ADDENDUM NUMBER 2

**LINCOLN COMPLEX – BUILDING O O.A.R., LIBRARY SERVICES AND I.T.
RENOVATIONS
930-B Oak Street SE, Albuquerque, NM 87106
ALBUQUERQUE PUBLIC SCHOOLS**

APS RFP No. 21-031-RRR

Date of Issue: 12/7/2020

A-802
SHEET ___ OF ___

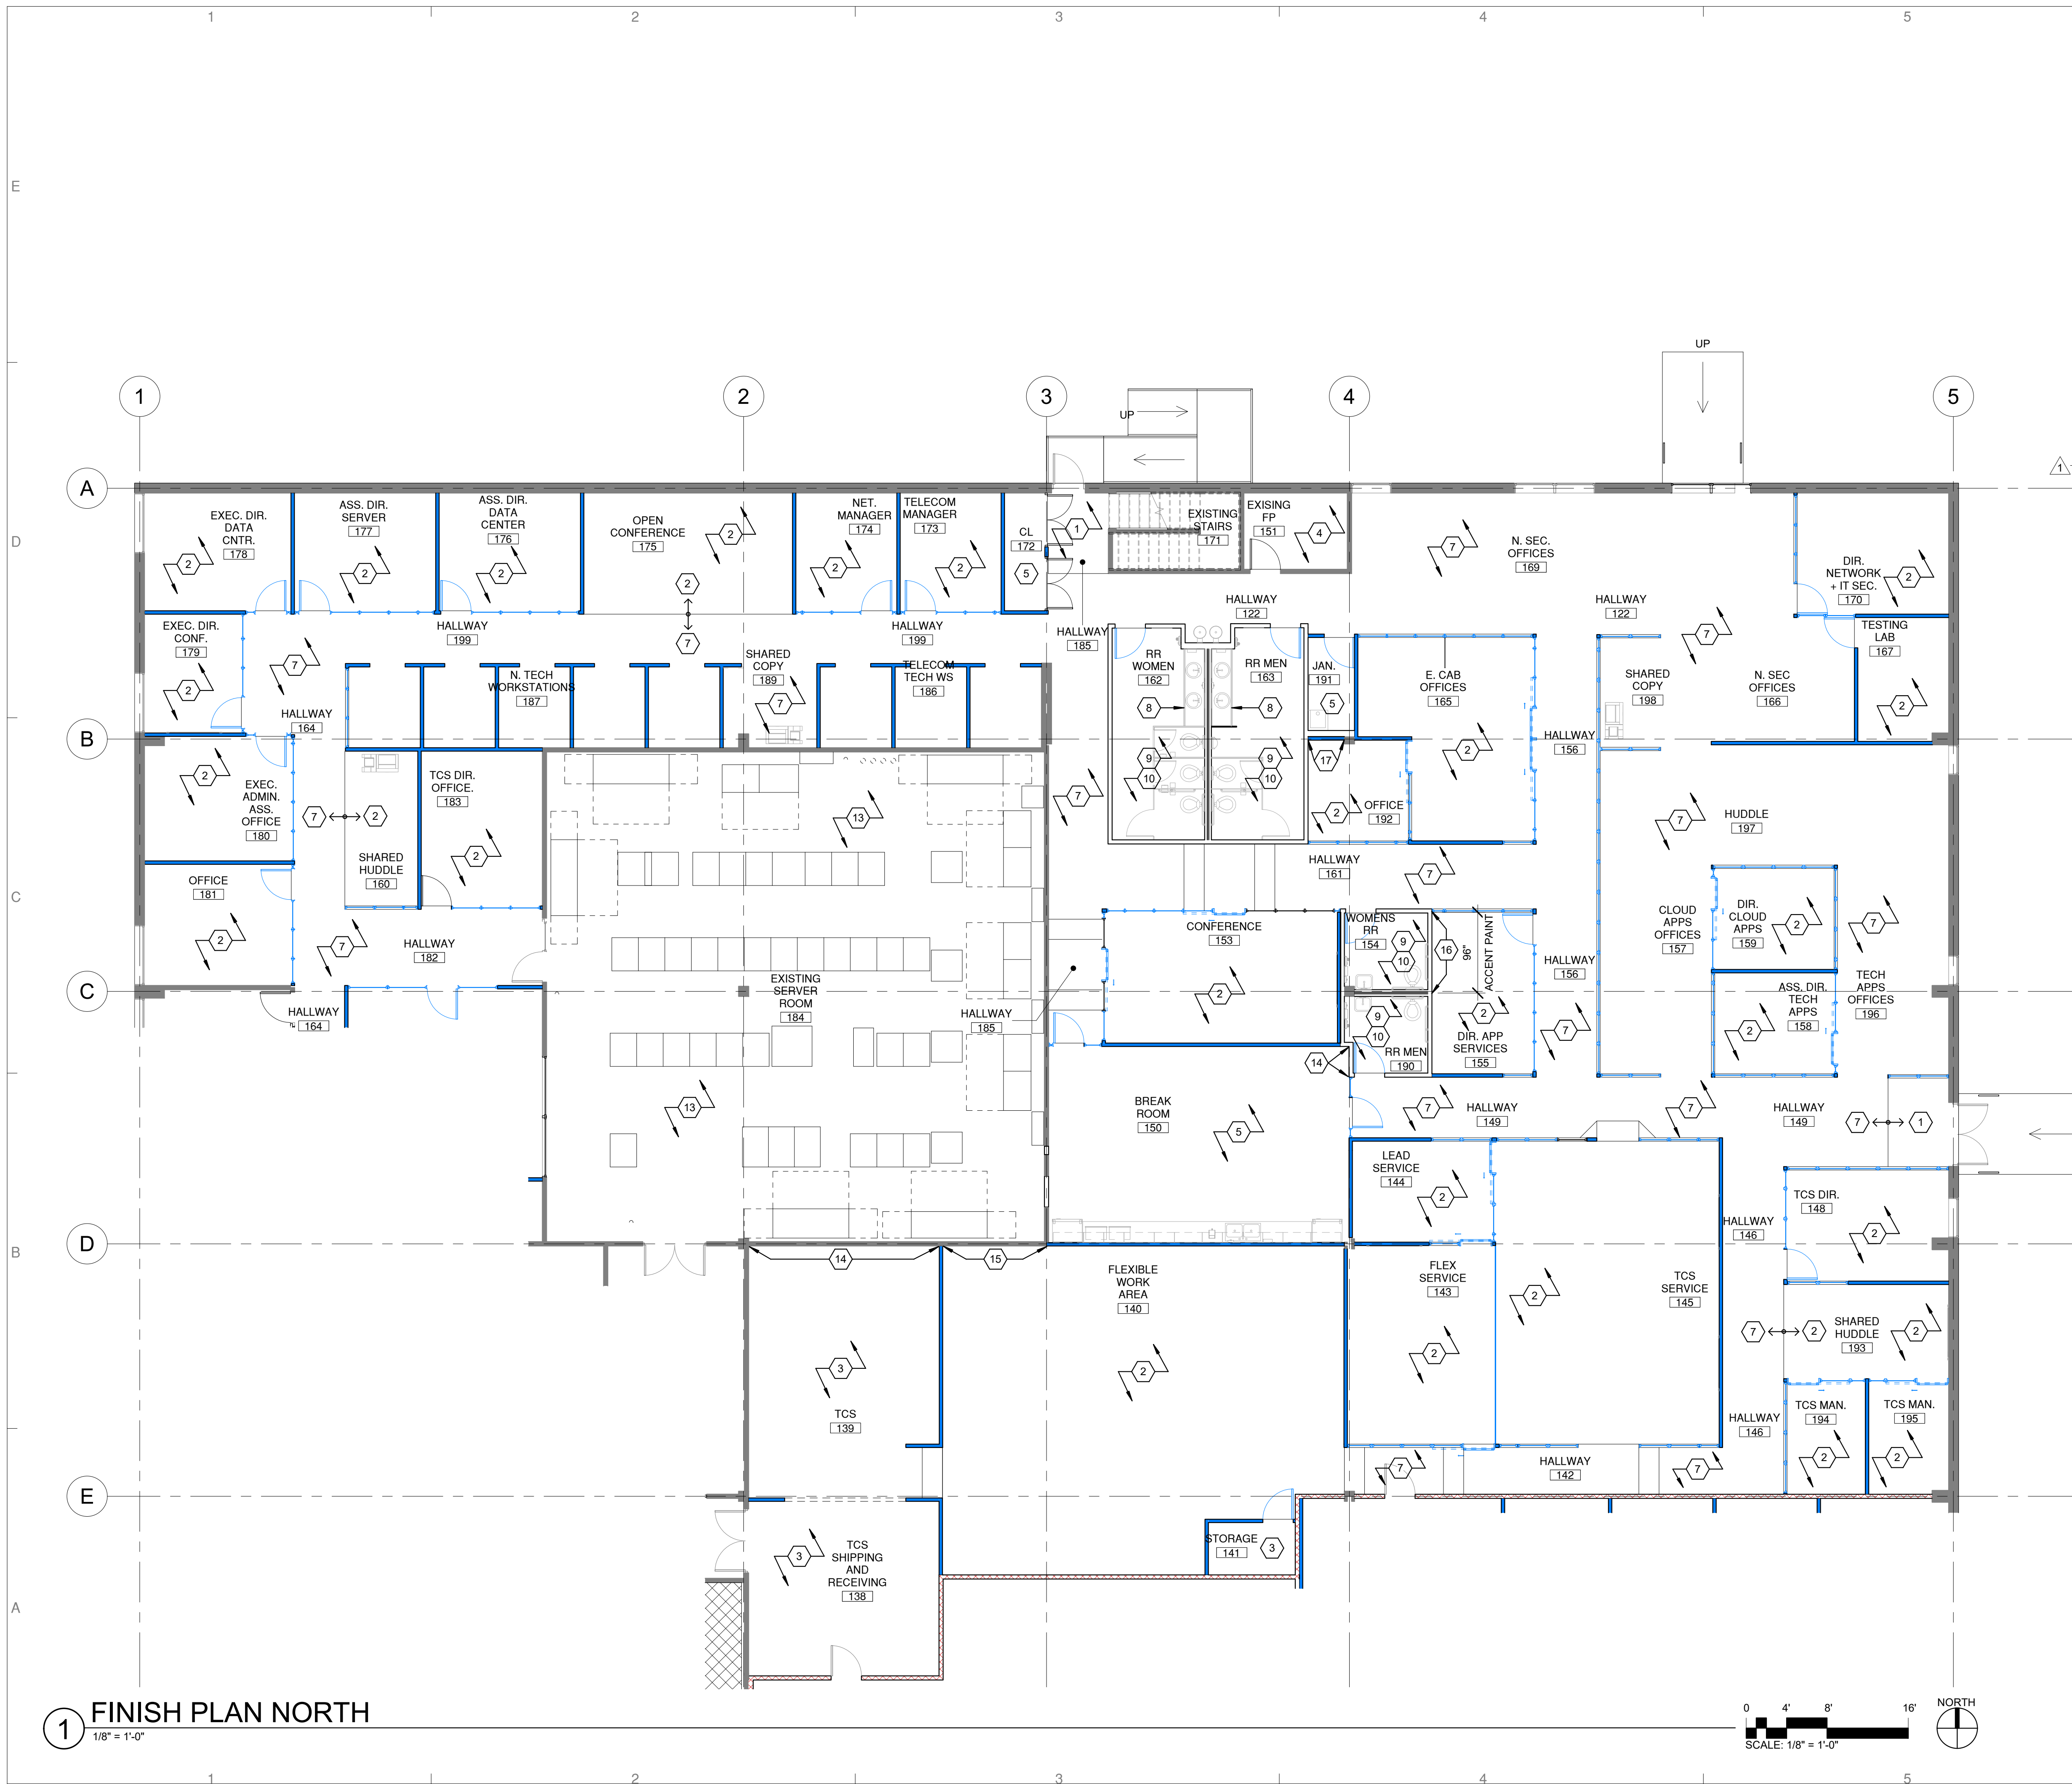
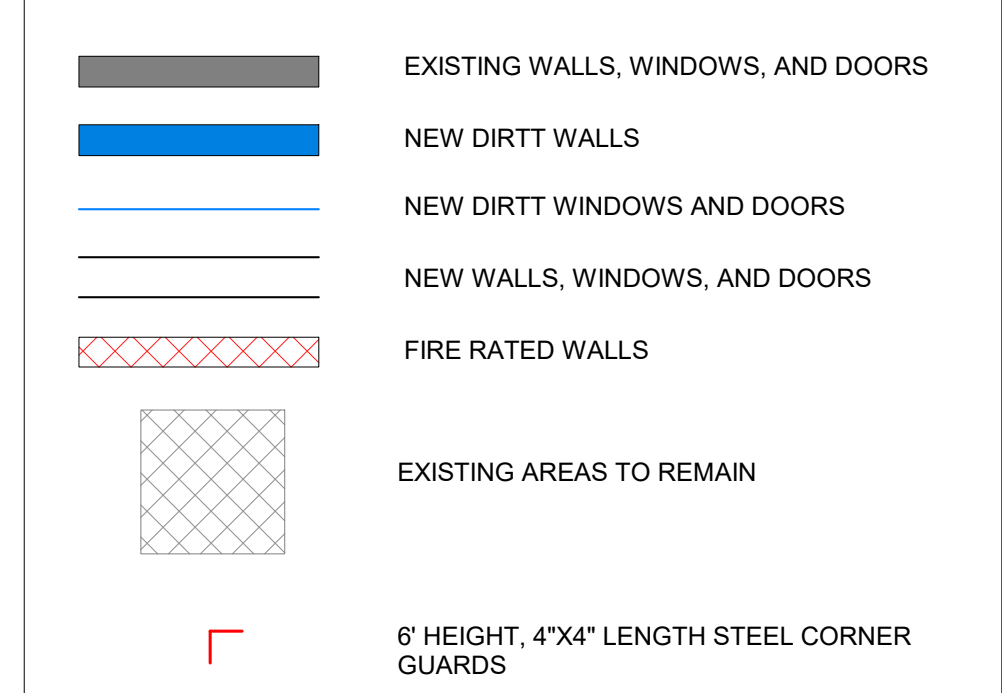
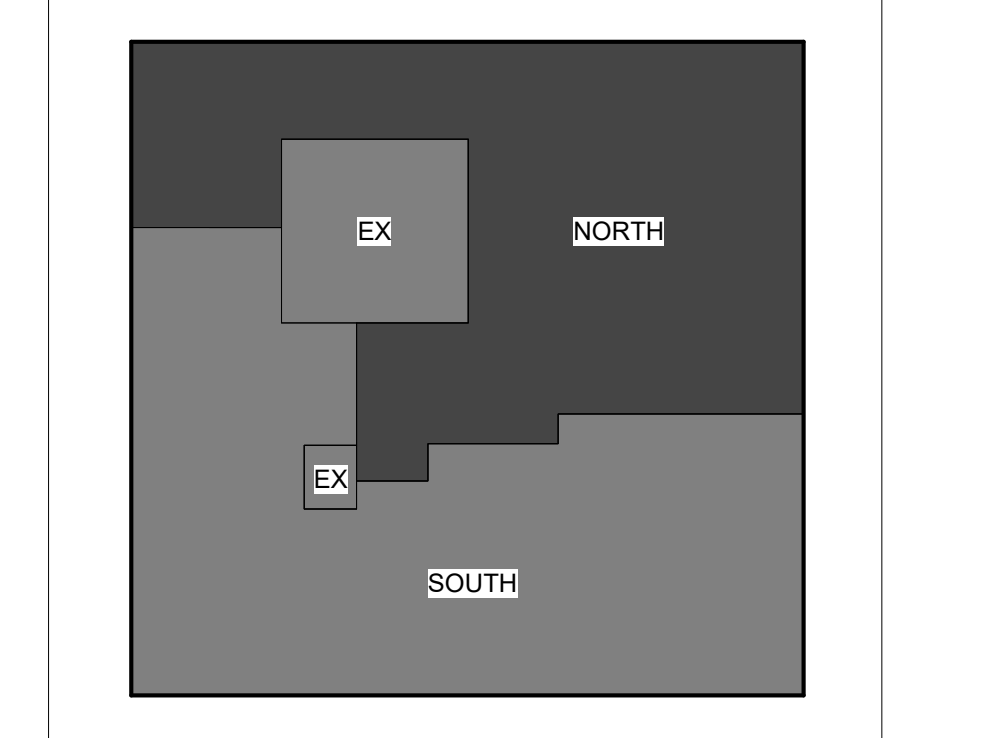
"Please clarify what walls will require base and what type."

Answer: All regular wall construction walls with gypsum board finish are to receive rubber wall base. Please refer to specifications section 09 65 13 for Resilient Base Accessories information. Please refer to attached A-801 and A-802 Finish Plans sheets for added general note about the wall base.

- L. ALL GYPSUM BOARD WALLS TO RECEIVE 4" HIGH RUBBER WALL BASE BY JOHNSONITE, COLOR TO BE "T44 GATEWAY WG."
